## **Explanation of Changes to the Draft NPO**

January 11, 2017

### 5. Vehicular Use Area and Off-Street Parking Requirements

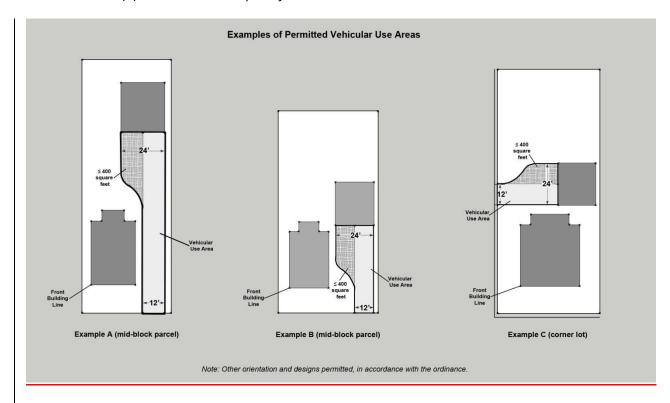
Feedback on this item was largely positive. One slight change (discussed below) was made to the possible location of the Parking Pad area. This is accompanied by an expanded chart showing examples of acceptable parking pad configurations. In these examples, case the front of the lot is at the bottom.

c. The original draft NPO requires that any expanded parking pad area be placed behind the house, while the new language says it may be placed <u>beside</u> the house, but no closer than 20' from the front property line. As a practical matter, this will only be possible for extra wide lots, but in those cases, this change may reduce overall paving since the driveway would not have to be extended to the rear of the house before expanding to create a parking pad. New parking pad areas are still not allowed in front of the house.

The maximum width of the vehicular use area shall be 12'; however, the vehicular use area may expand up to 24' in width to accommodate garage access and parking. The total additional vehicular use area beyond 12' in width shall:

- (1) Be behind the front building line;
- (2) Be not less than 20' from the front property line; and
- (3) Not exceed 400 square feet.
